MICE-NOTE-GEN-362

Before & after South Mezzanine modifications

J Tarrant 16/01/12

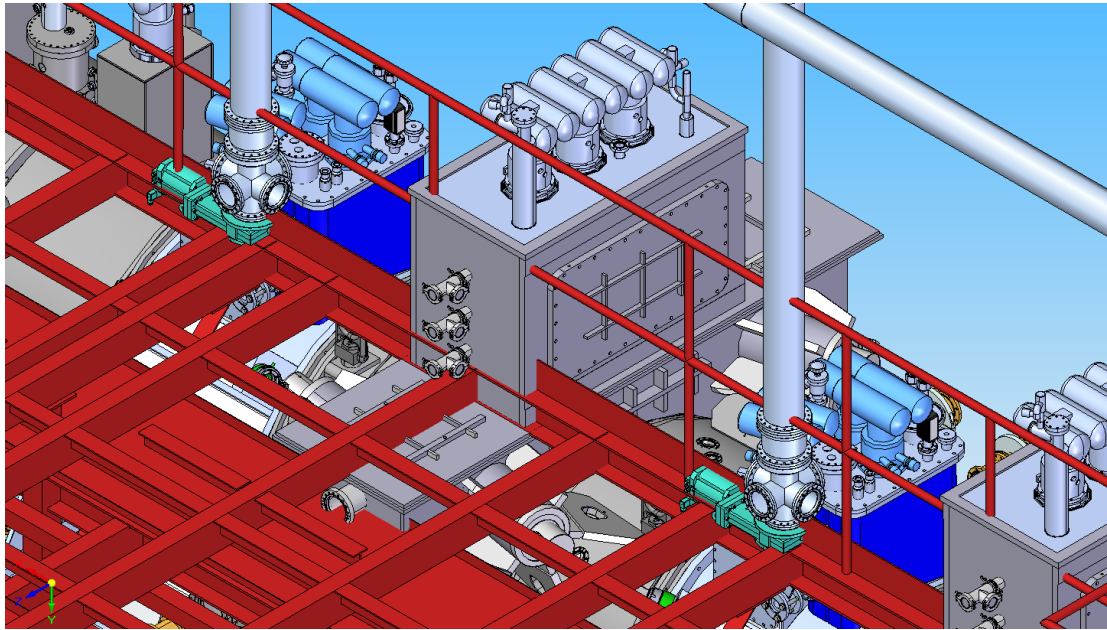
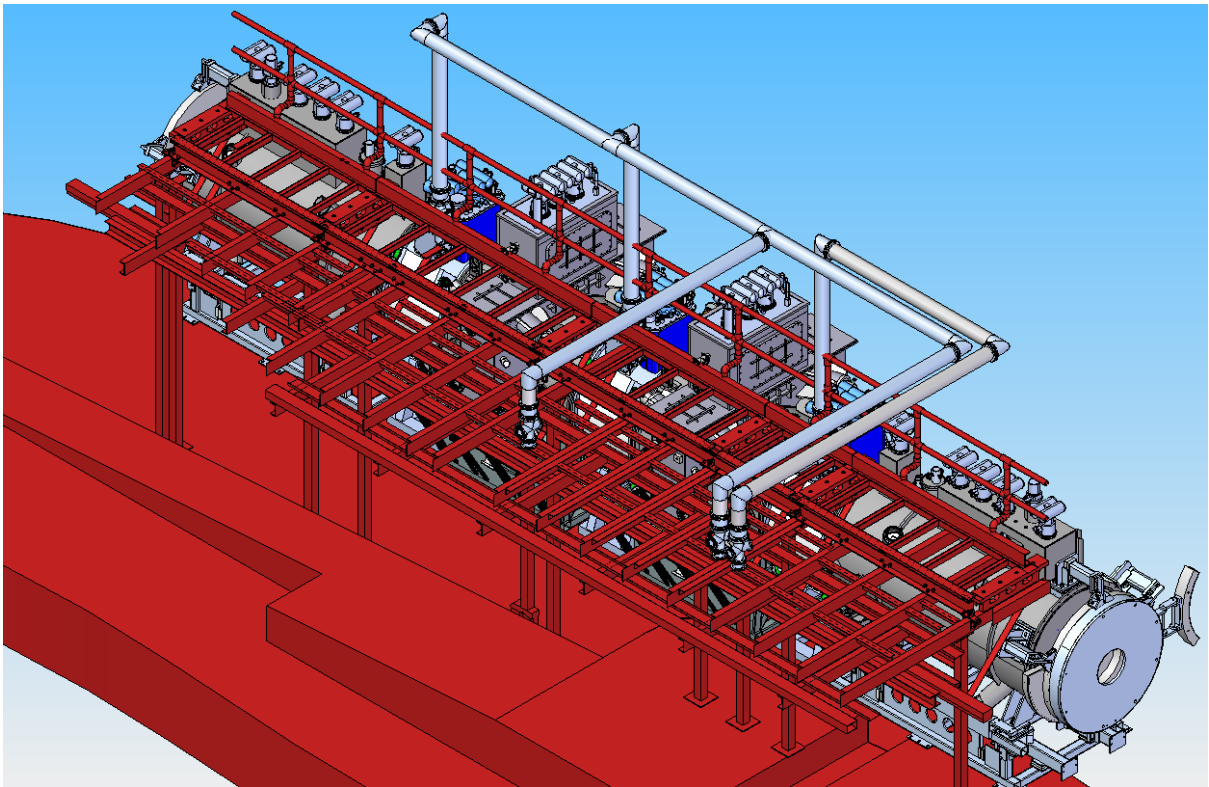
This view shows the current South Mezzanine with the top floor plates removed

This view is a close-up of the above view showing how the RFCC body and turret and the AFC services clash with the front of the South Mezzanine

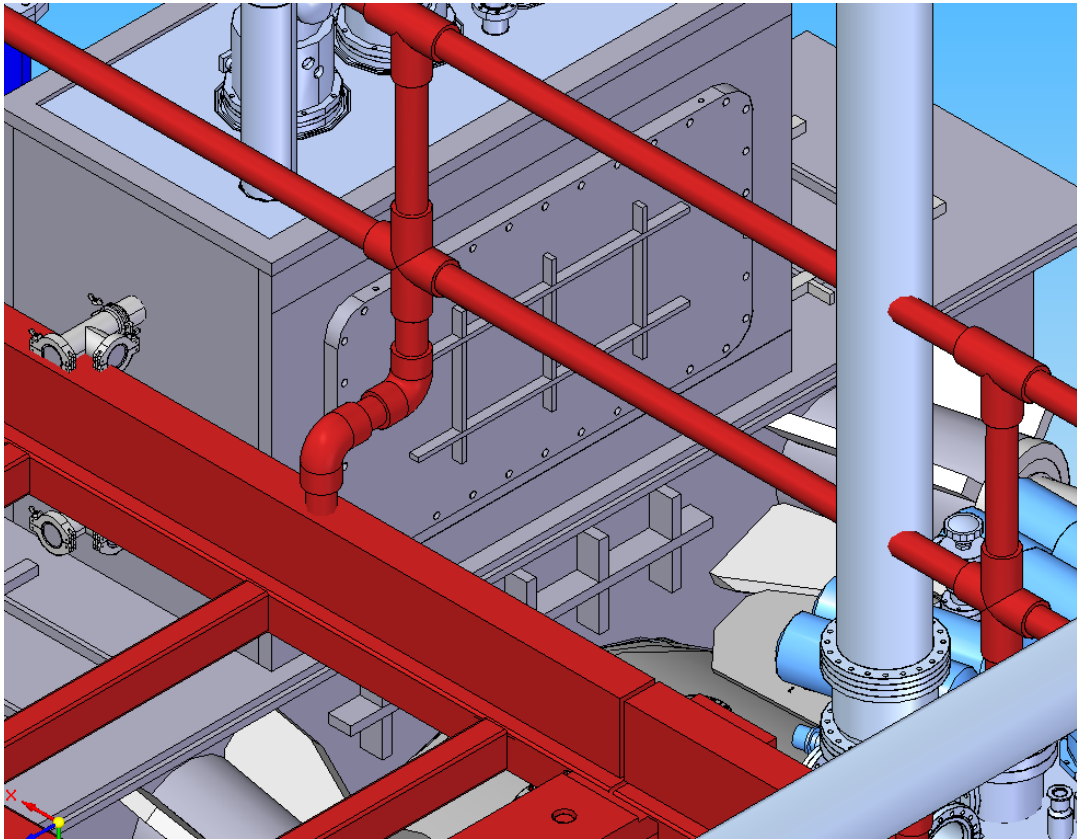
This view shows the proposed South Mezzanine, again with the top floor plates and hinged platform plates removed

This view shows how there is now clearance between the front of the South Mezzanine and the RFCC. The vacuum connections shown clashing with the Mezzanine are being moved to the other side. There is still a clash with the AFC services shown however the handrail will be locally modified to avoid this. Bringing the whole handrail back to avoid the clash will overly restrict access along the now shortened and raised gangway.

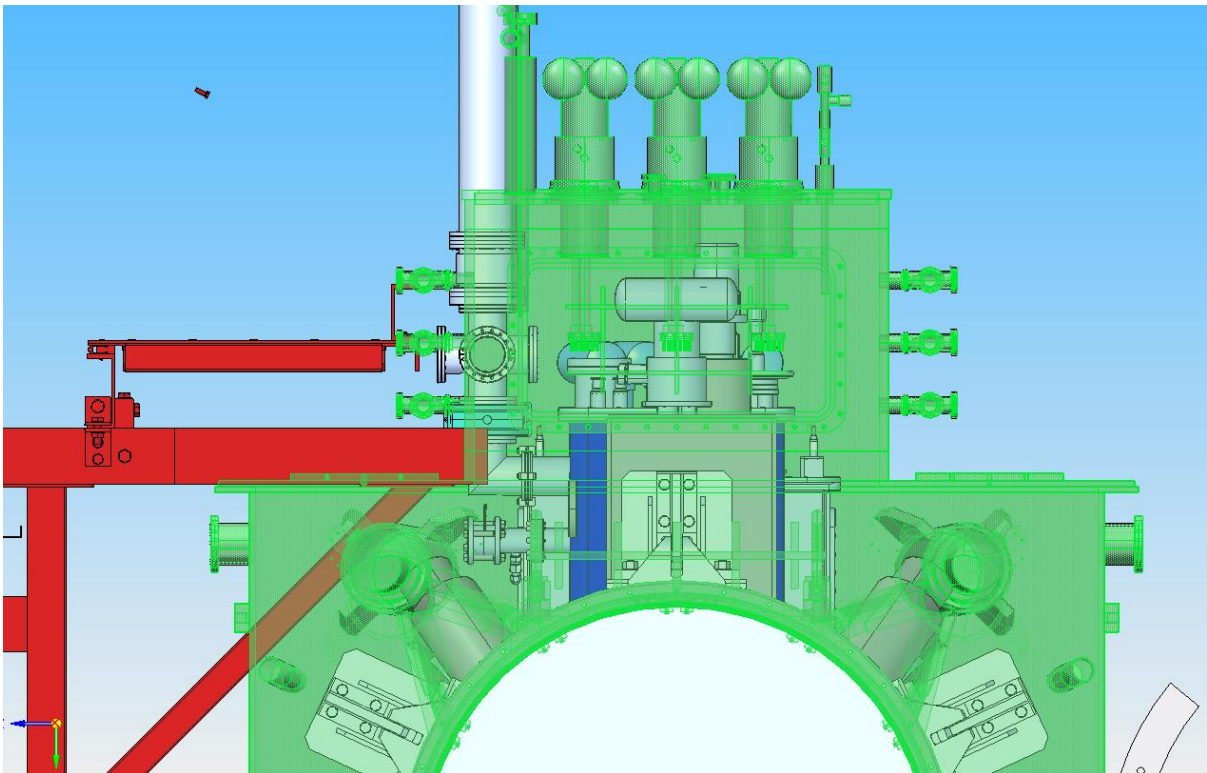
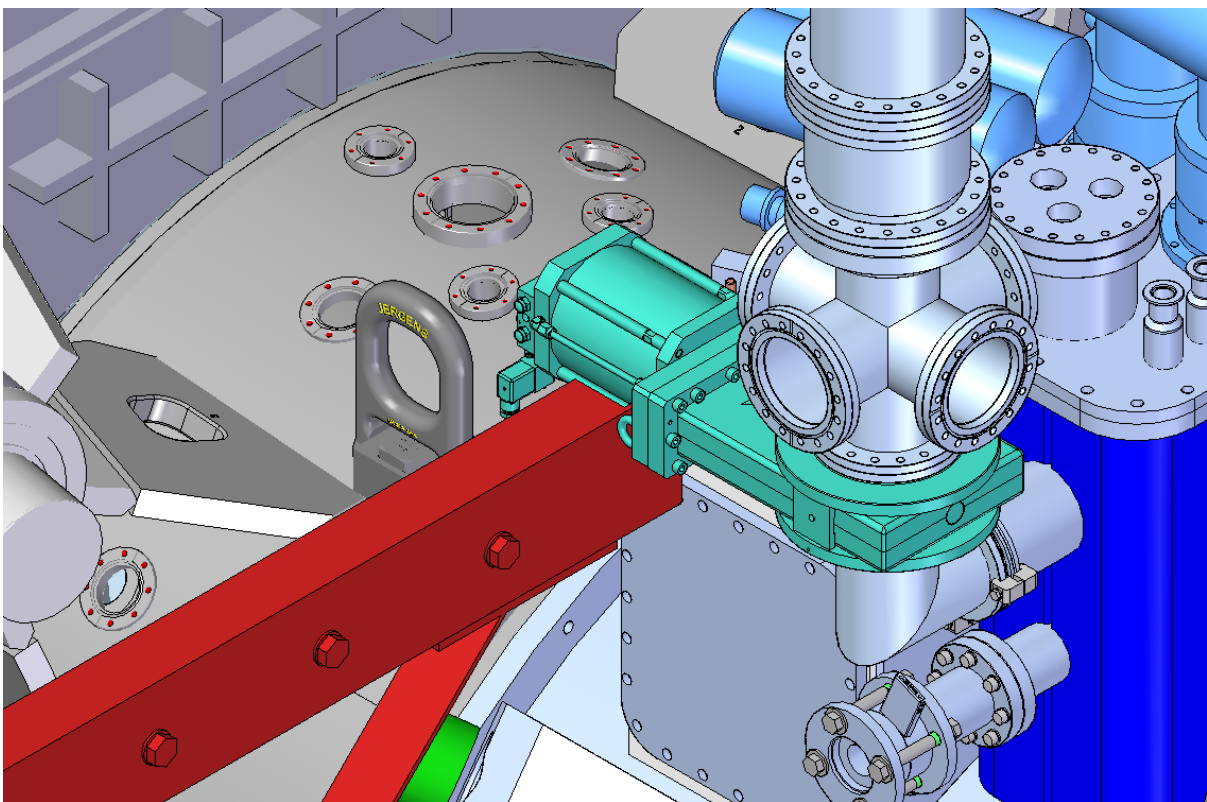
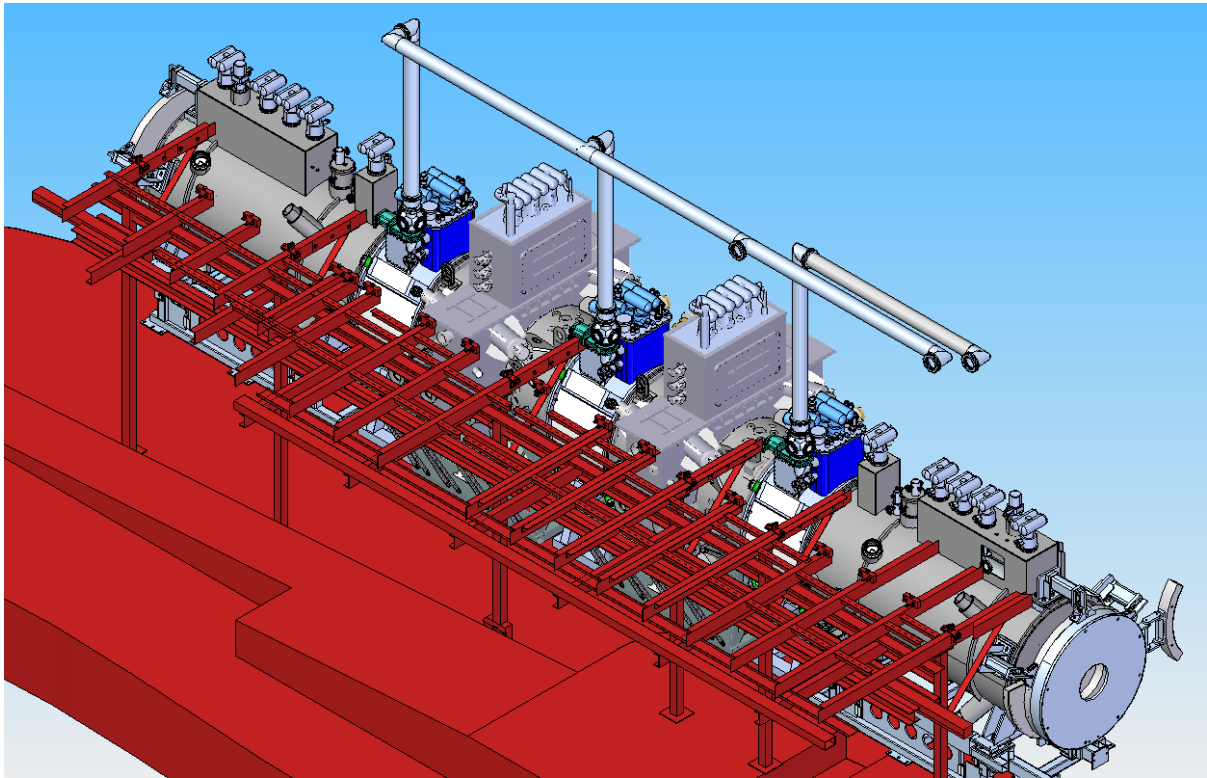
This view shows the RFCC (highlighted in green) with the hinged platform, the only clash will be the vacuum ports which are being moved to the opposite side of the RFCC turret. There looks like there might be a clash between the RFCC and the cantilever beams, however this is just the angle of view as shown below the cantilever beams do not align with the RFCC along the direction of the experiment axis.

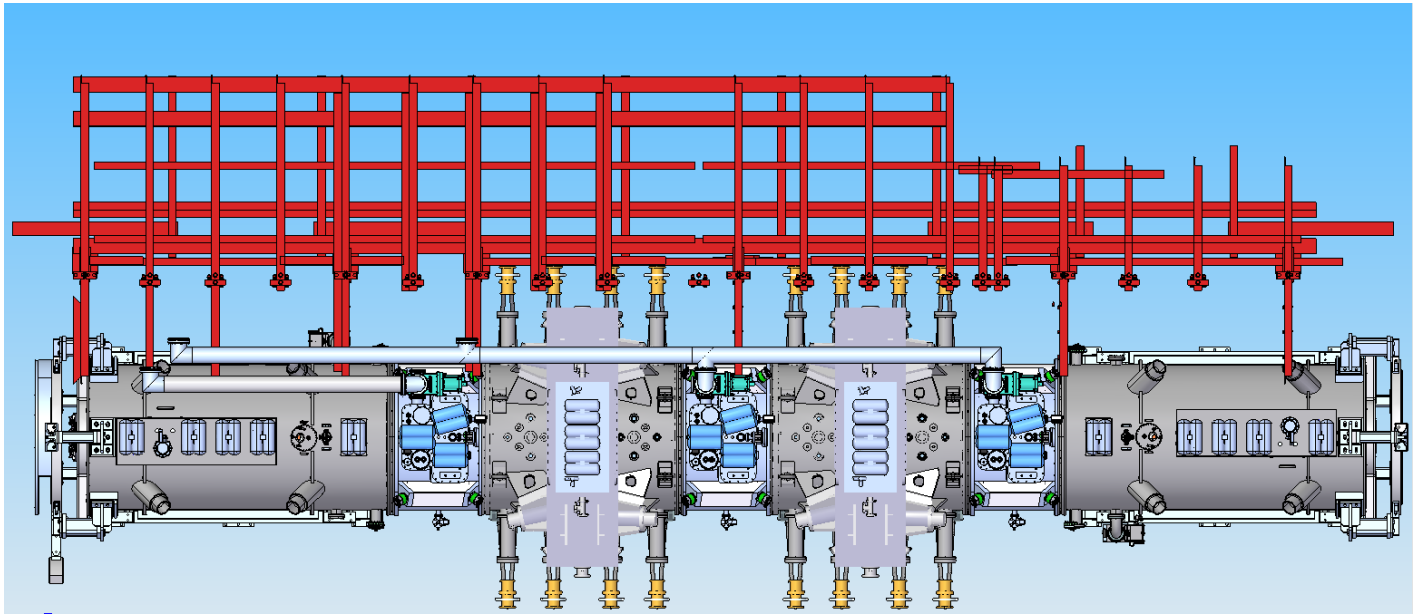
There is a potential clash between one of the cantilever beams and the AFC services (dependant on final placement of the devices) however this is easily resolved by cropping the end of the aluminium alloy beam.

Top view showing the position of the cantilever beams with the devices of the MICE cooling channel

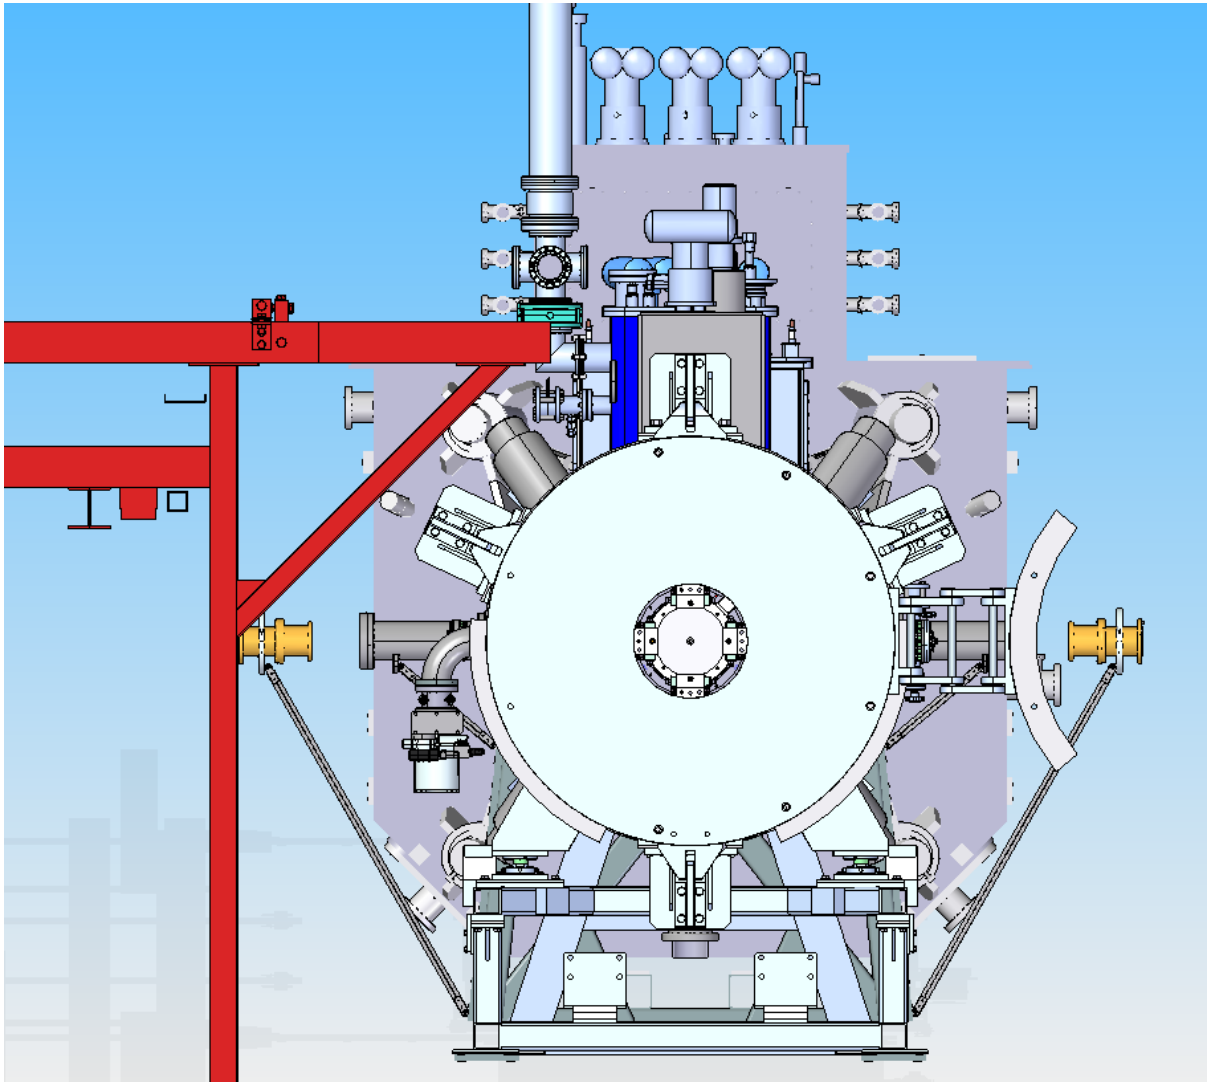
This shows how the supported cantilever beam has sufficient clearance from the Spectrometer Solenoid and AFC devices.

EMR compatibility with hinged platforms

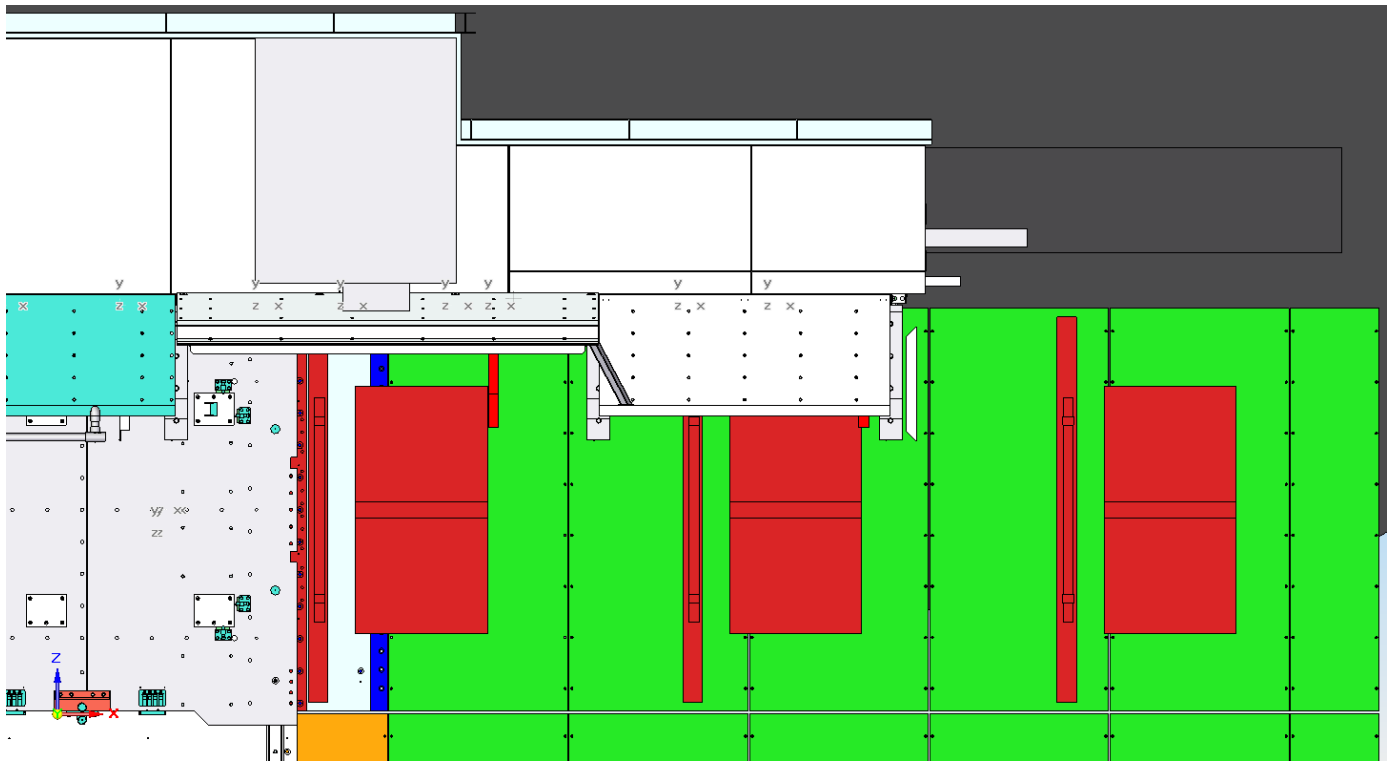
This view shows the EMR in Step IV, V & VI positions. It can be seen with the hinged platform raised (Step IV position) that there is full access over the EMR to crane it in.
